## PROPOSAL FOR A DEFINITION OF THE LOWER WINDSCREEN REFERENCE LINE AND JUSTIFICATION

As chapter 3.31. "Windscreen lower reference line" (GR PS 143 rev1)

Figure X1: Lower Windscreen Reference Line

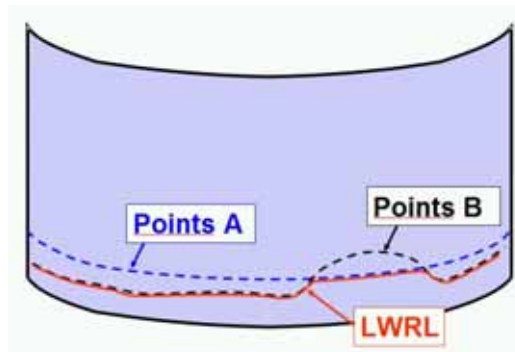
The „Lower Windscreen Reference Line“ is the geometric trace of the furthest forward Lower Windscreen Reference Points A or B. Reference Points A and B are defined for each lateral position of the windscreen as mentioned below (see Figure X1):

Figure X2: Lower Windscreen Reference Points A

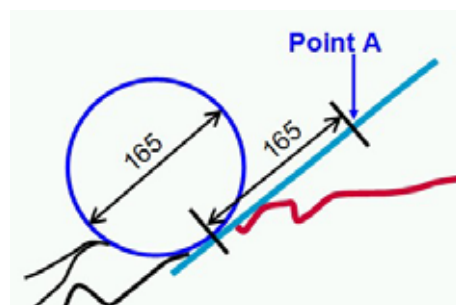
„Lower Windscreen Reference Points A“ are the points 165 mm rearwards along the windscreen from the points of contact between a sphere and the windscreen, while determining the bonnet rear reference line according to paragraph 3.6 (see Figure X2).

Definition of Points A logically applies to the windscreen the procedure which exists to define the rear bonnet reference line.

Figure X3: Lower Windscreen Reference Points B

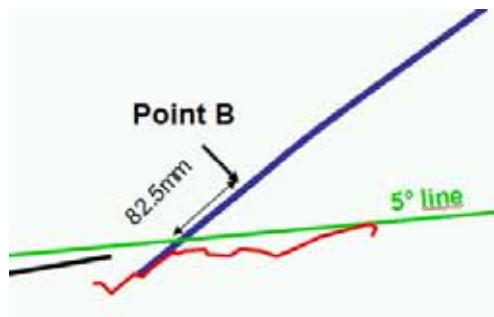
„Lower Windscreen Reference Points B“ are the points 82.5 mm rearwards along the windscreen from the points of intersection of lines in vehicle longitudinal planes projected rearwards, inclined  $5^\circ$  upwards with respect to the ground reference plane as defined in paragraph 3.15 and contacting the uppermost surface of the instrument panel (see Figure X3).

Definition of Points B takes into consideration the constraints faced by the manufacturers in the very first stage of vehicle concept: driver's field of vision and other primary safety functional requirements such as demist/defrost, etc. These constraints limit the amount of space available between the windscreen and the instrument panel and therefore determine the ability to meet HIC requirements.
